TECHNICAL REVIEW AND EVALUATION OF REMEDIAL ACTIONS
1916 WEBSTER STREET
ALAMEDA, CALIFORNIA

Housing Authority of the City of Alameda
701 Atlantic Avenue
Alameda, California 94501

Versar, Inc. - Sacramento
5330 Primrose Drive, Suite 228
Fair Oaks, California 95628-3520

May 20, 1994

Figure 2

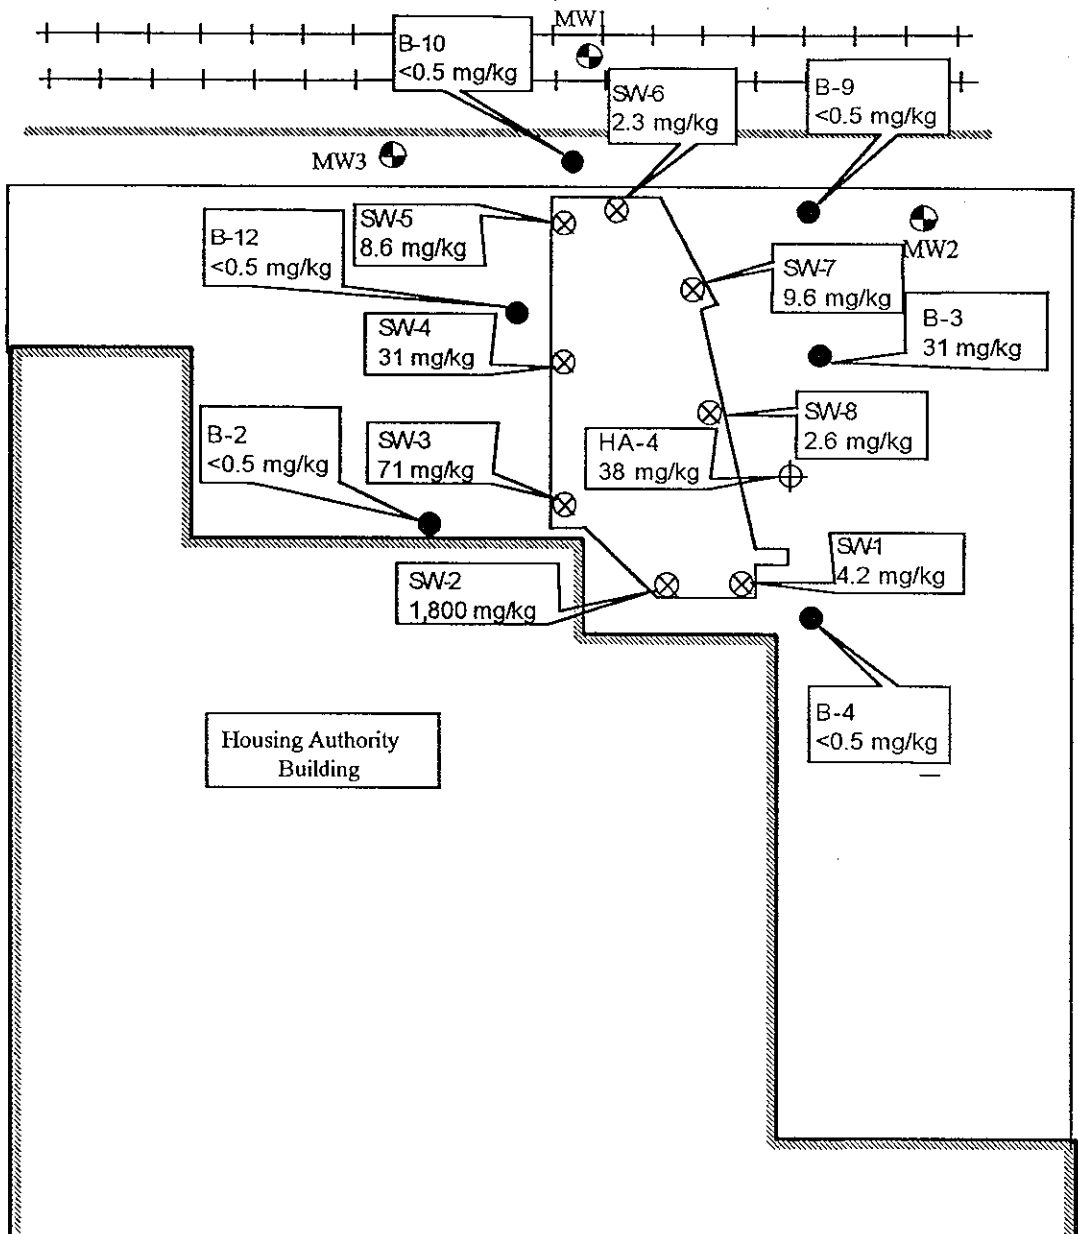
On February 10, 1994, ESE produced a Corrective Action Plan (CAP) for the site. The remedial activities proposed in the CAP included removing up to 160 cubic yards (yds³) of soil, 50 yds³ of which was expected to be contaminated. Between March 3 and March 5, 1994, ESE excavated approximately 220 yd³ of contaminated soil and stockpiled it at the site. Laboratory analysis of soil samples collected from the perimeter of the excavation indicate that two areas of contamination still remain. Figure 2 shows the extent of the excavation and the concentrations of total petroleum hydrocarbons as gasoline (TPH-G) identified at the perimeter of the excavation.

1800 ppm TPH-G at SW-2

Figure 3

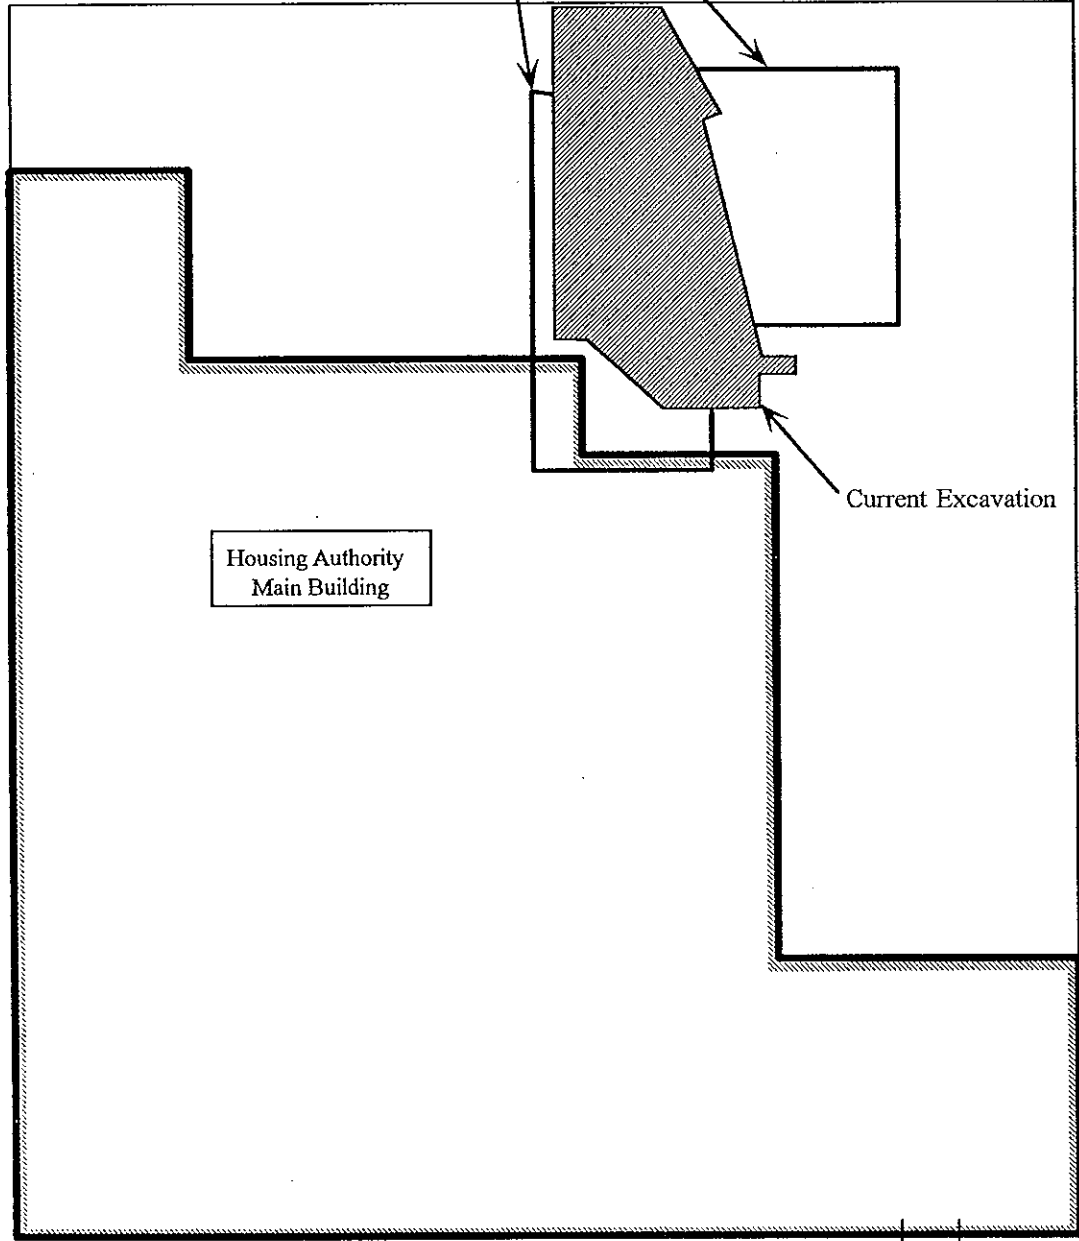
The ESE remediation did not address all contaminated soils at the site. Based on laboratory analytical results from the ESE work and previous investigations, contaminated soil is present at the southwest corner of the excavation where site structures prevent continued soil removal extending north to within 15 feet of the fence line, and up to 35 feet east of the excavation. Figure 3 shows the estimated maximum extent of the remaining contamination.
